Addendum Number 3

Project: Cone Center HVAC Modernization
The University of North Carolina at Charlotte
SCO Project # SCO #16-12981-01

Date: July 19, 2017

Refer to the following attached revised drawings for changes, per Revision 1, dated 7-19-17:

MOTOR CONTROL SCHEDULE ABBREVIATIONS:

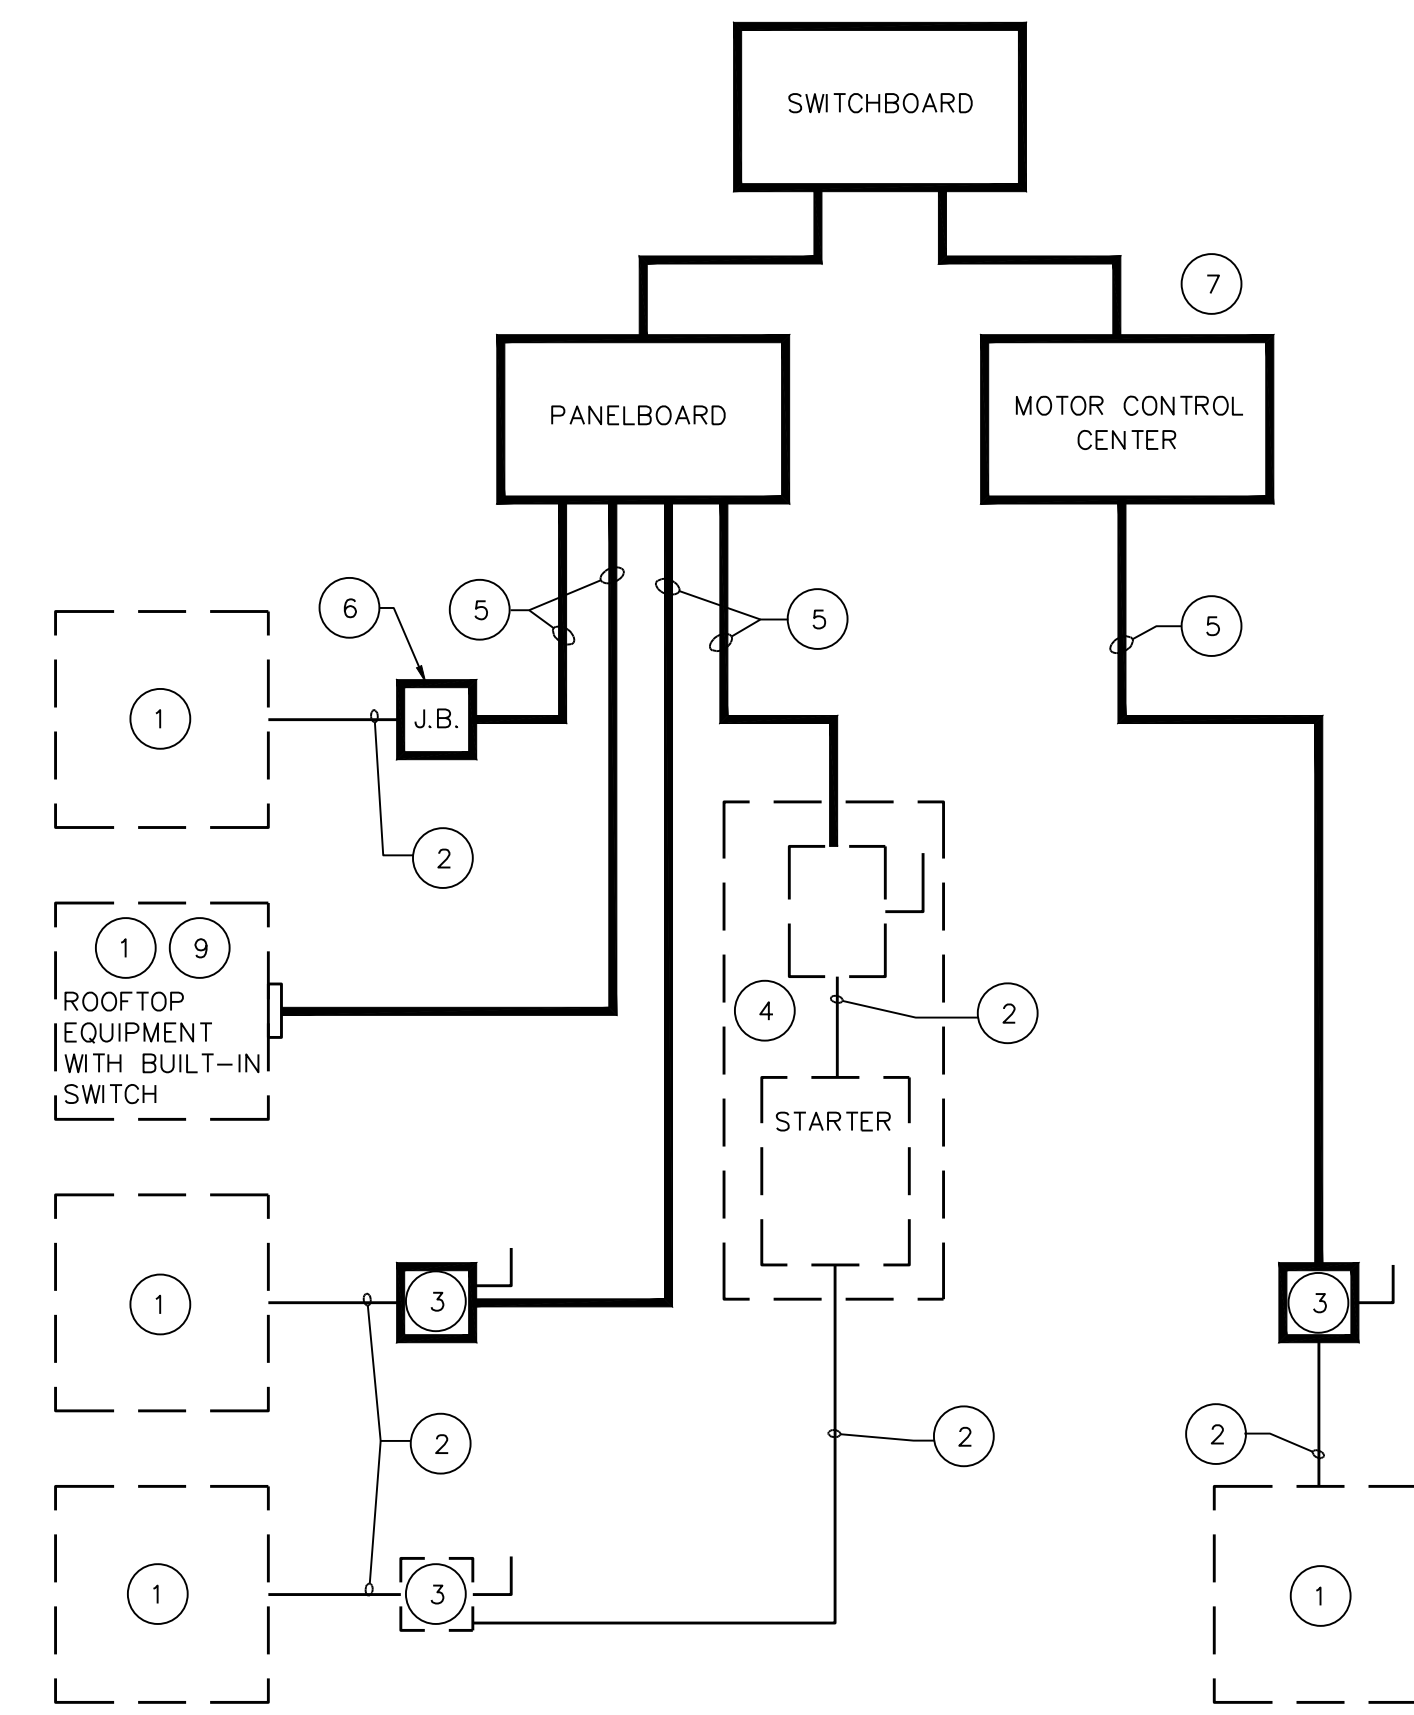
EXCEPTION: FOR THIS PROJECT, THE WIRING FROM THE CT-1 AND CT-2 VFDs IN MECHANICAL ROOM 230 TO THE DISCONNECTS AT THE COOLING TOWERS SHALL BE BY THE ELECTRICAL CONTRACTOR DUE TO THE WIRING DISTANCE AND COMPLEXITY OF THE WIRING INSTALLATION. THE COOLING TOWER DISCONNECTS AT THE TOWER ENCLOSURE SHALL BE BY DIVISION 26. DIVISION 23 SHALL WIRE FROM THESE DISCONNECTS TO THE TWO COOLING TOWERS.
